DEVELOPMENT REVIEW COMMITTEE (DRC) COMMENT REPORT

Project Name: Aquamarine Shine LLC / Aquamarine Shine

Case Number: R15045

Request: Site Plan Level III Review: Waterway Use / Eight
(8) Unit Cluster Development

DRAWING NO.
A-1

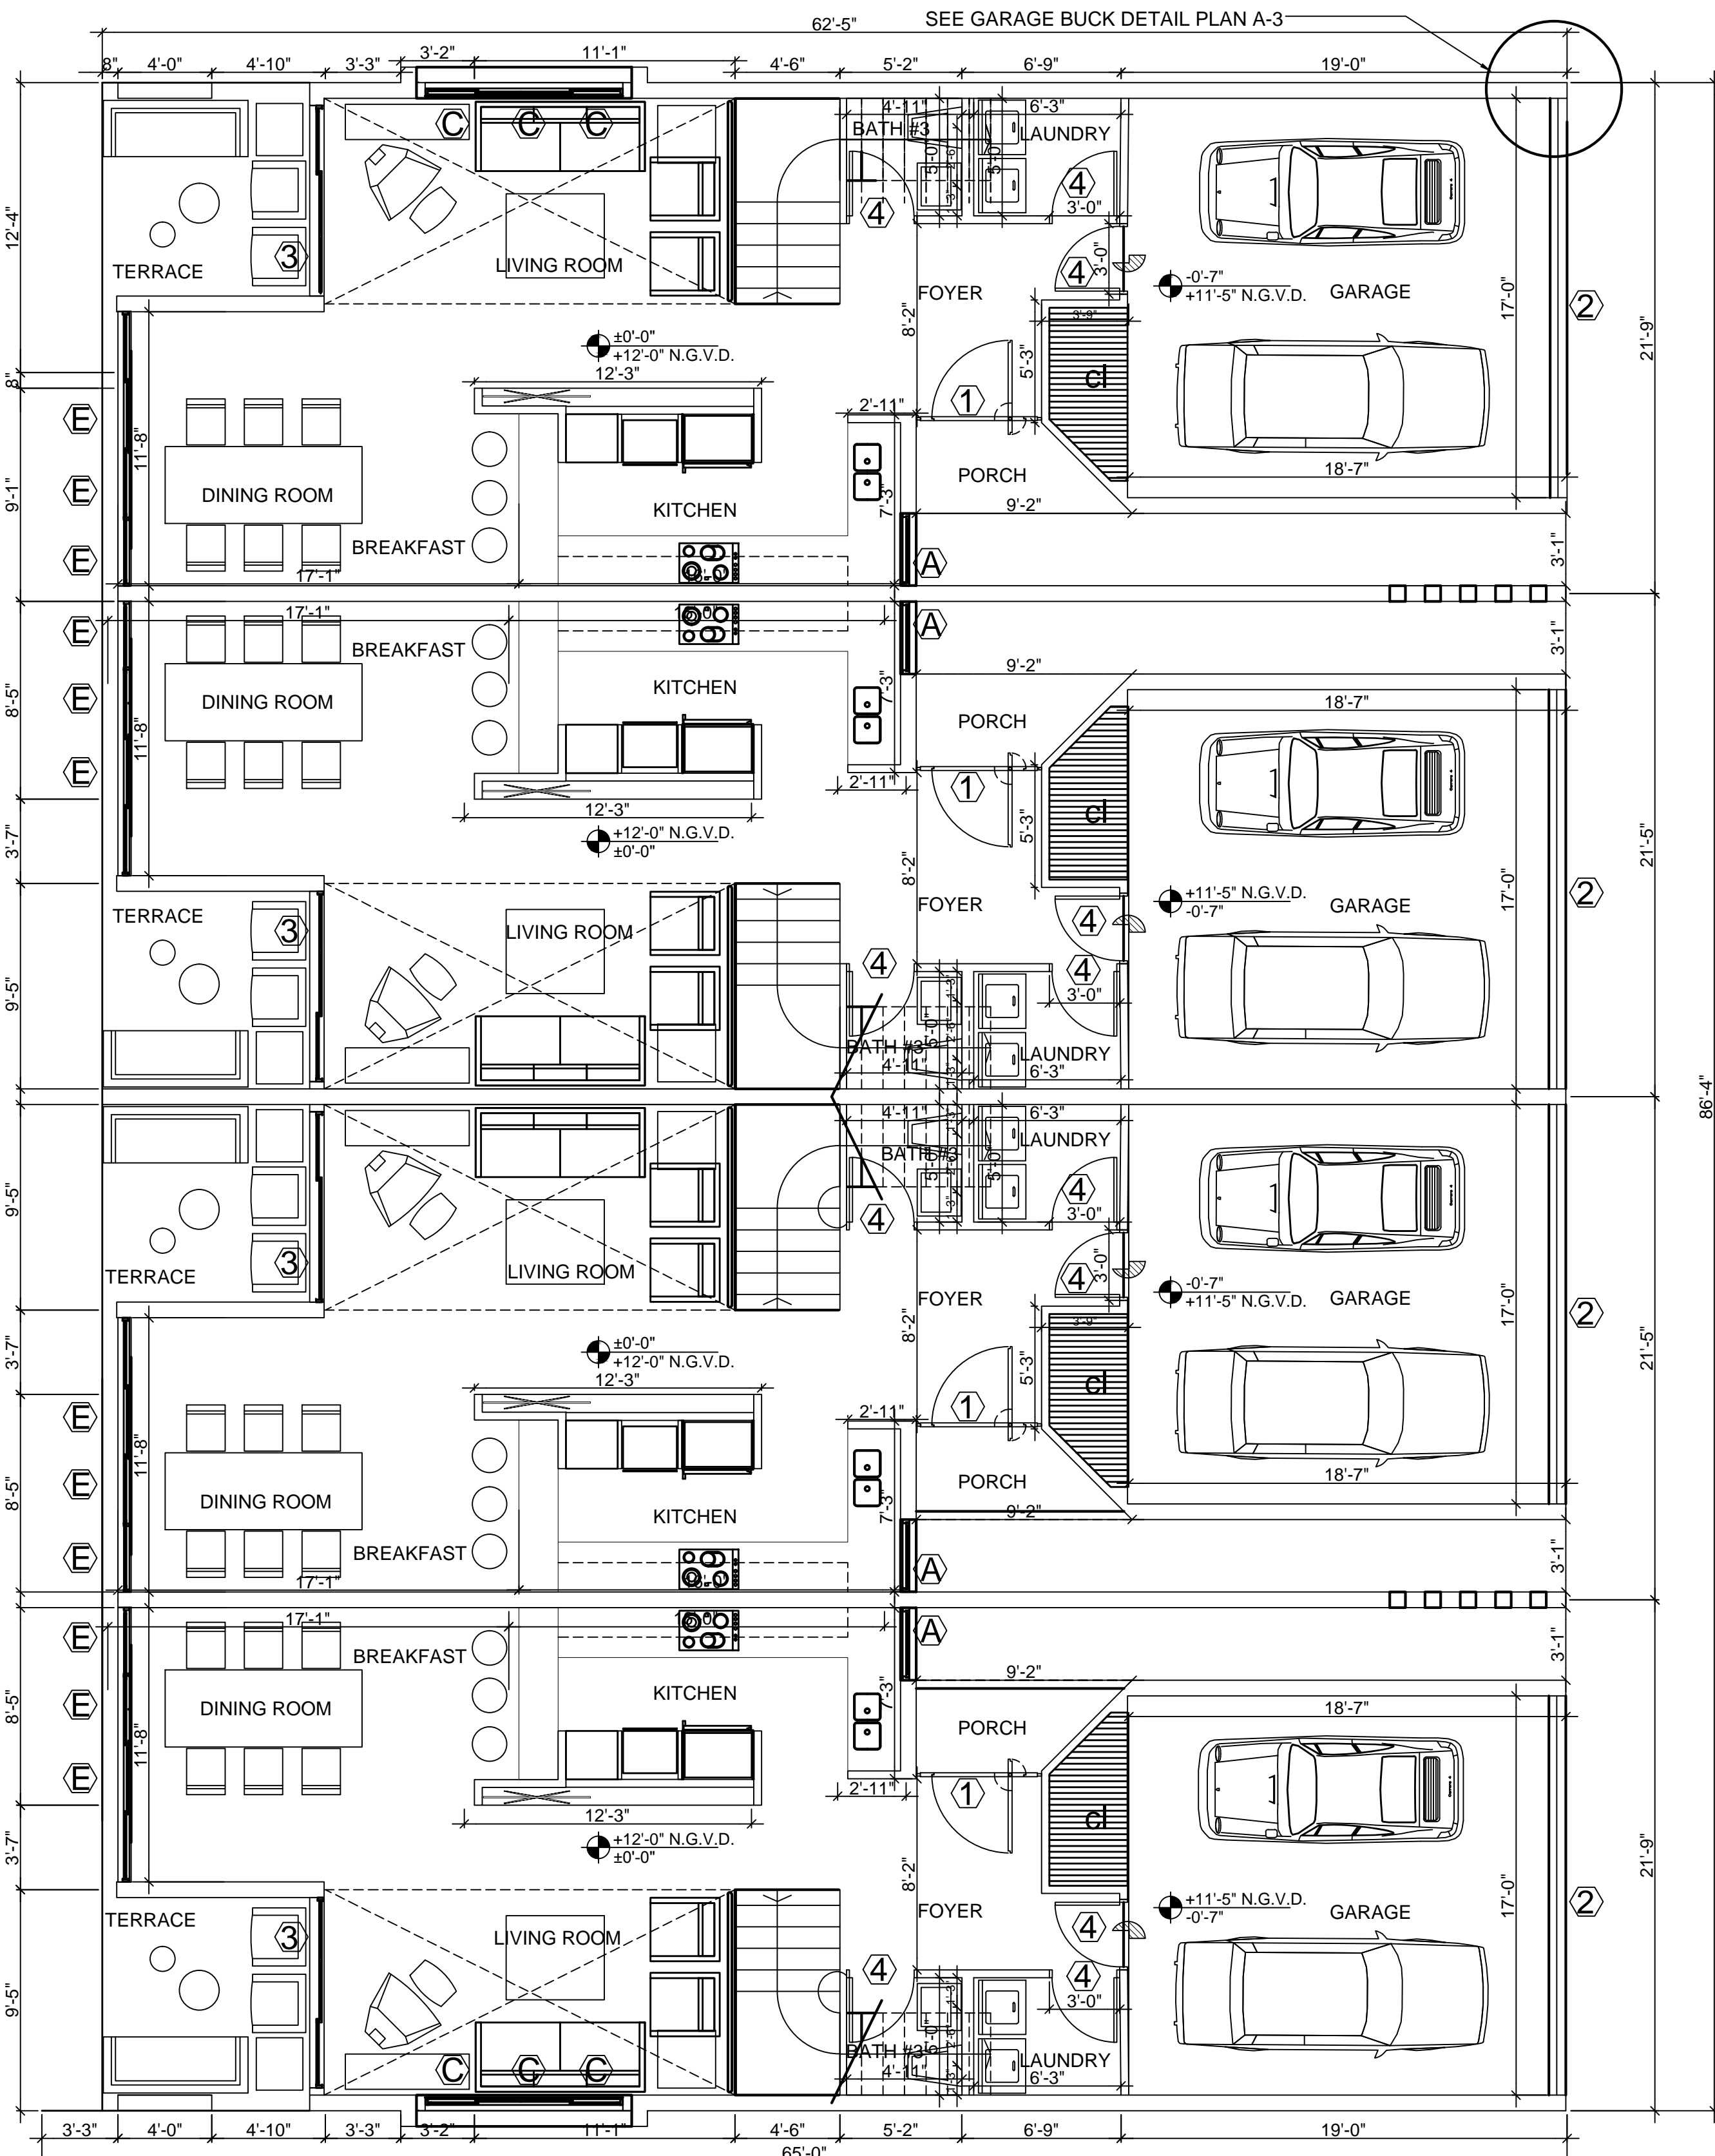
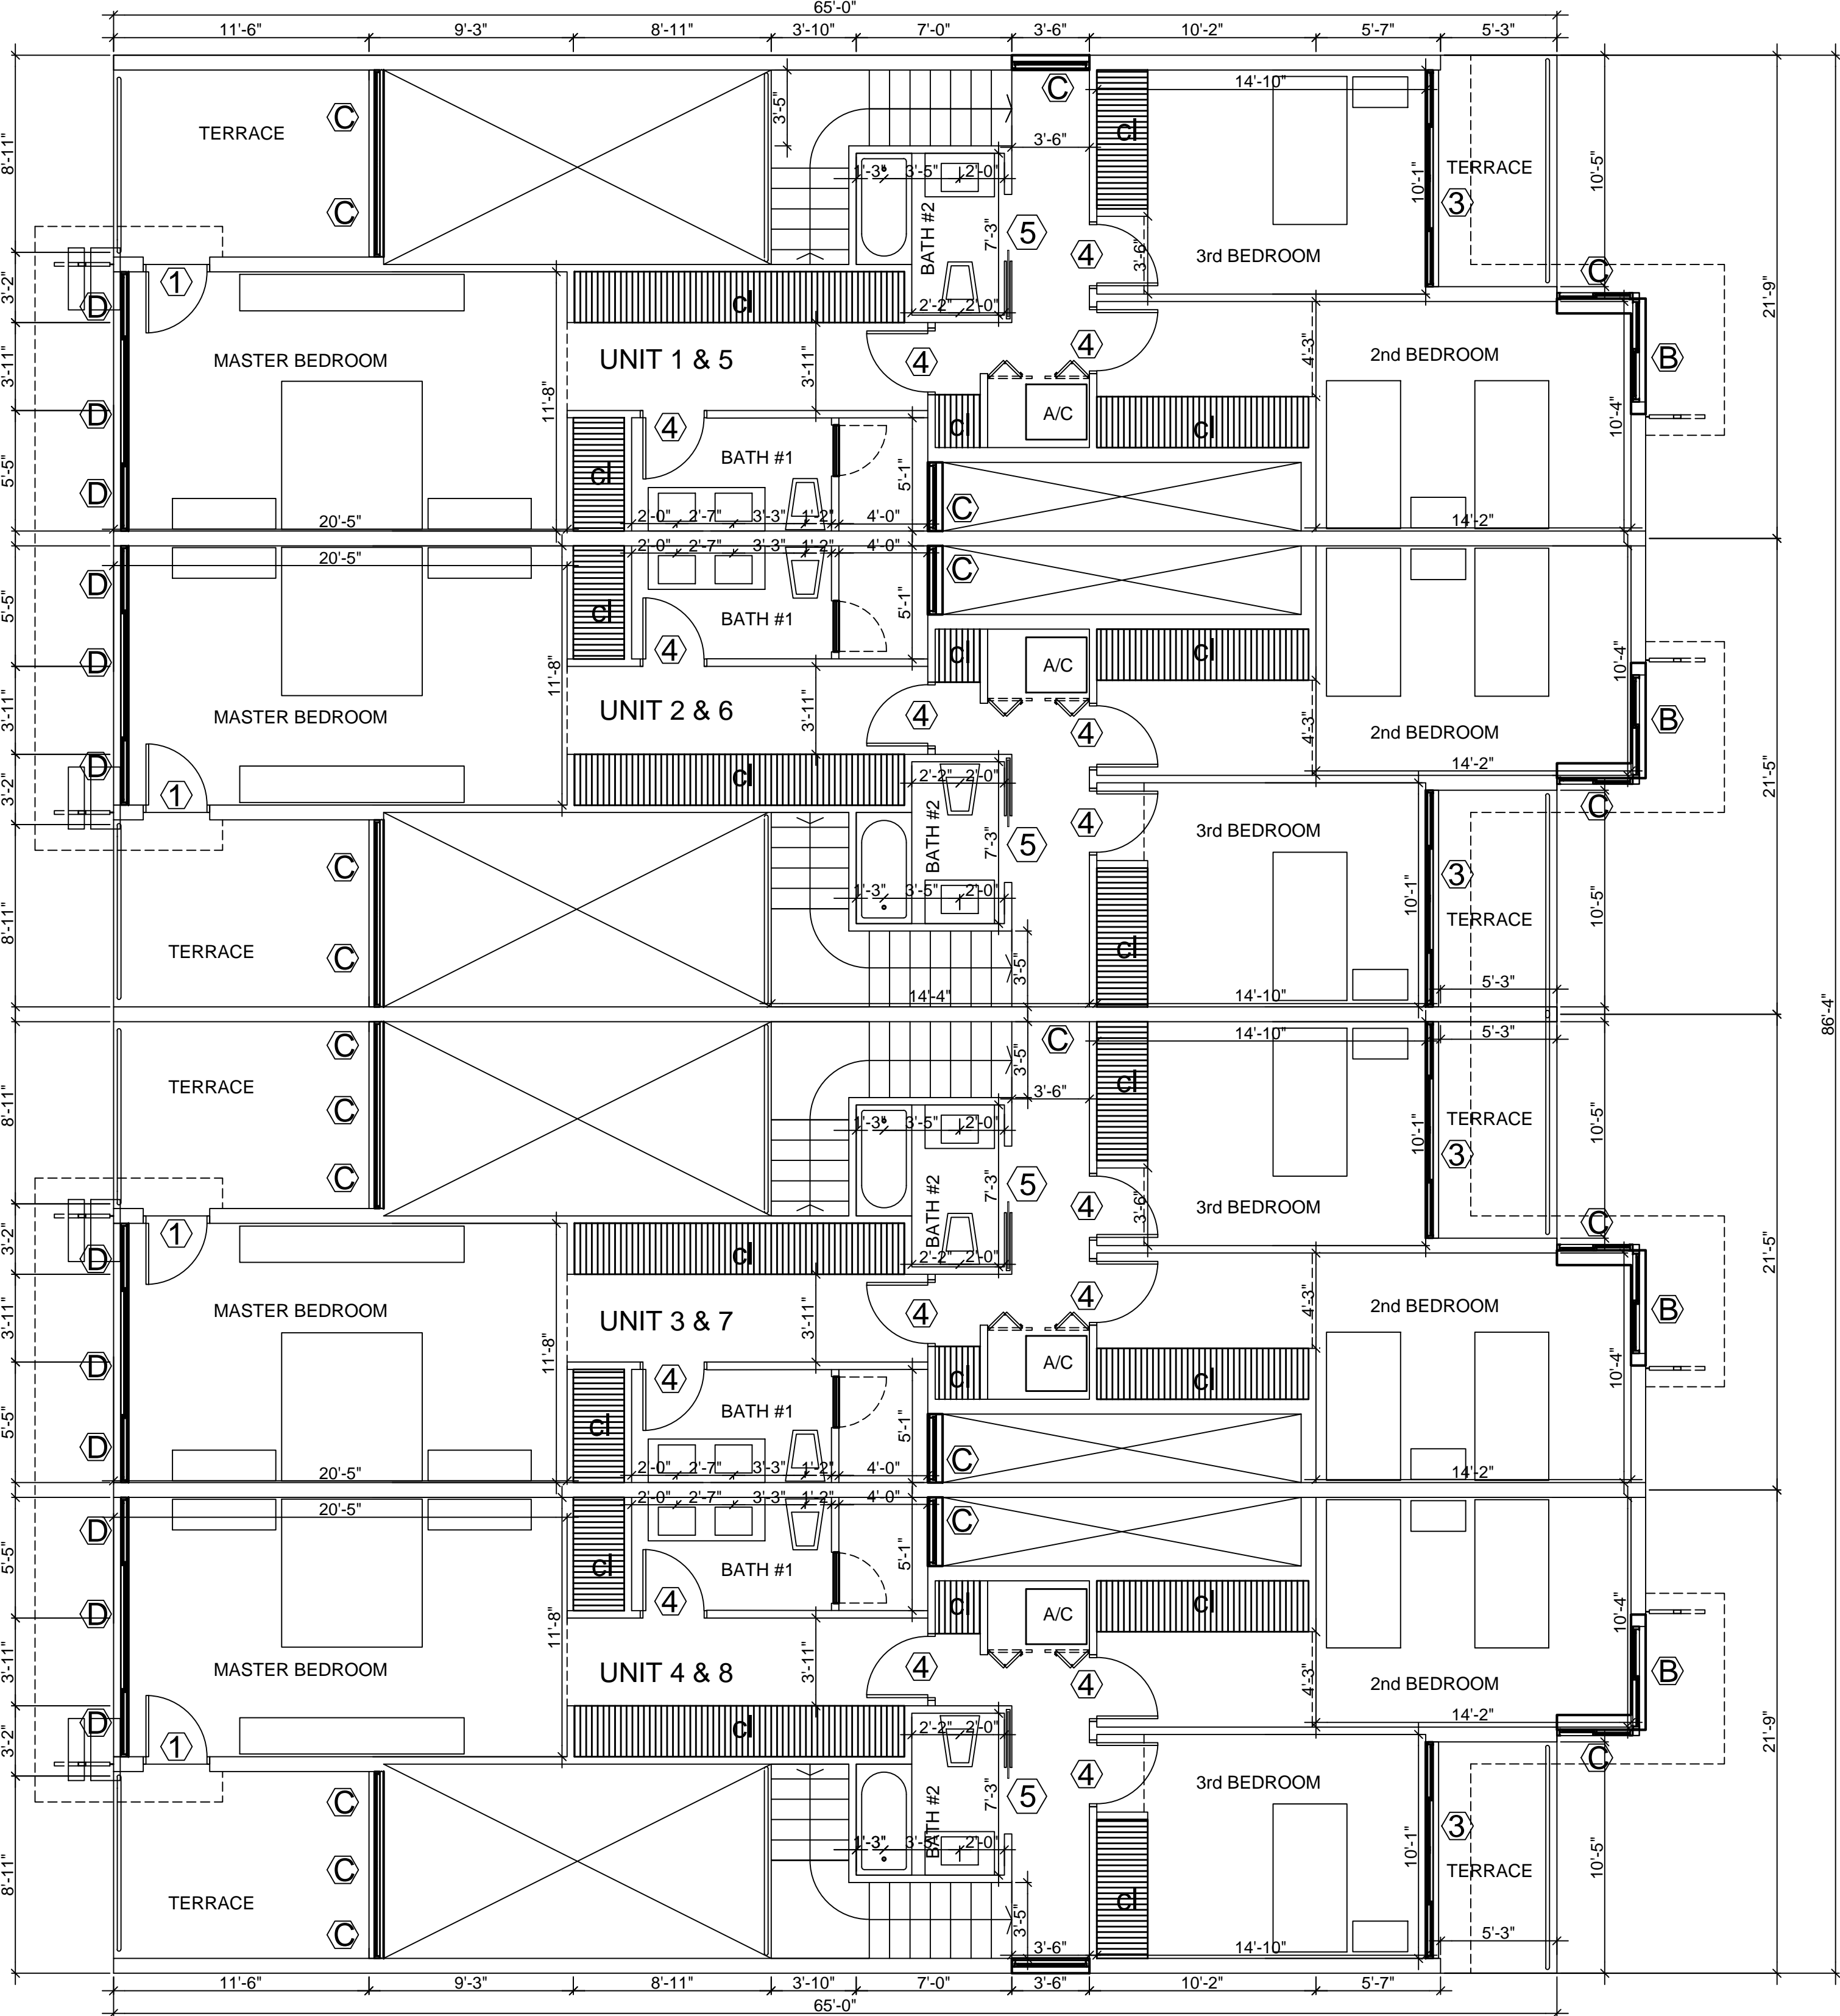
- 8) Provide the following changes to the site plan and elevations:
- a. Reconfigure the ground floor to provide a pedestrian connection to the units located along SW 9th St.

- b. Provide an access easement on the site plan as required per Sec. 47-18.9.C.4.
 - c. Indicate the height of the buildings on the elevations. If any portion of the building exceeds twenty-two (22) feet in height, that portion of the structure shall be setback an additional one (1) foot for each foot of height.
